57 Main Street
Housing Development
Urban Affairs
January 22, 2019

Special Permit
57 Main Street
Housing Development

DECISION ON AN APPLICATION FOR SPECIAL PERMIT

TAVERN ON THE GREEN

**LAYOUT PLAN
TAVERN ON THE GREEN
- 57 MAIN STREET -
MARLBOROUGH, MA**

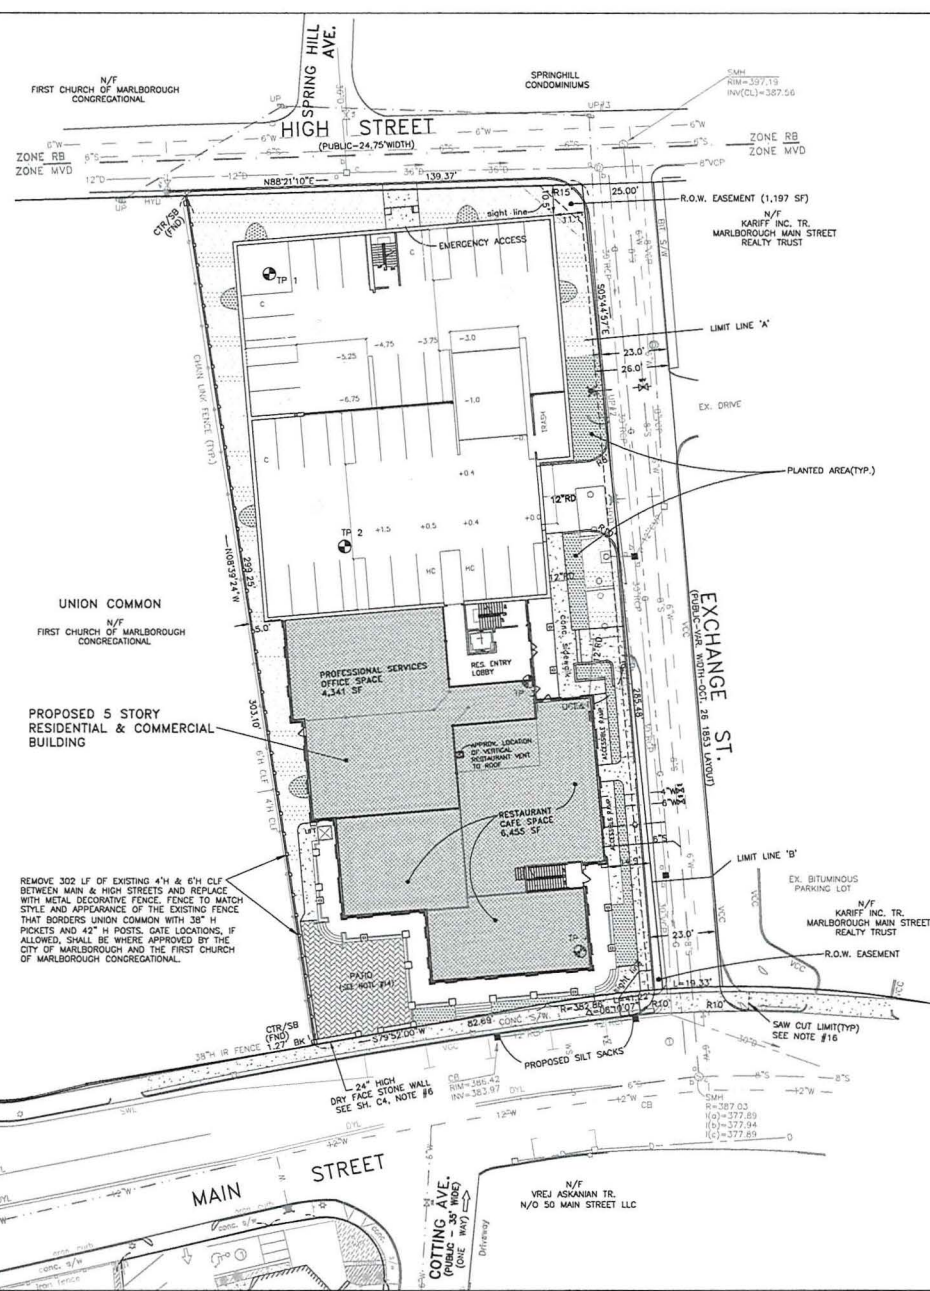
6. Exchange Street is presently approximately nineteen feet wide near the intersection of Main Street. The City Engineer expressed concerns that the roadway could not safely accommodate the increase in traffic that the project will generate. As there is no room within the right-of-way limits to widen the street, the applicant has agreed to grant a permanent easement to the City of Marlborough for the purpose of widening the street. An Easement Plan has been drafted and submitted to the DPW Engineering Division for review. The Site Plans show that, with the proposed widening, Exchange Street would be a consistent twenty-three feet wide from Main Street to High Street. The encroachment of the street pavement onto the property contributes to the increase in lot coverage for which the Special Permit is sought. The applicant has also agreed to make other improvements to Exchange Street. At its intersection with Main Street, the concrete apron will be removed and the wheelchair ramps will be replaced, and; at its intersection with High Street, the radius of the rounding will be increased.

Open Space. The Site Plans do not quantify the Open Space required in the Ordinance vs. what is proposed - the approval conditions should require that this information be provided for consideration by the City Council.
